Item No 6.1

Application No DA-2025/167

Property 2 Fox Lane Rockdale (aka 401-405 Princes Highway

Proposal Integrated Development - Amendment to DA-2016/150

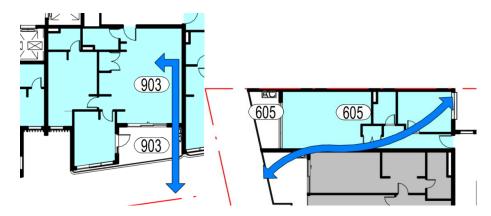
DA-601 Rev A, submitted with the application, is a cross ventilation plan. The drawing indicates that 38 of 59 (64%) dwellings receive cross ventilation and includes corresponding diagrams to support this figure.

Upon assessment, the assessing officer notes that only 30 of the 59 dwellings appear to achieve cross ventilation, based on their layout, orientation, and associated external openings. In particular, units 106, 208, 308, 407, 506, 605, 903, and 905 are not considered to achieve cross ventilation as suggested by the applicant.

An excerpt illustrating these units is provided below. It shows, for example, that unit 903 is
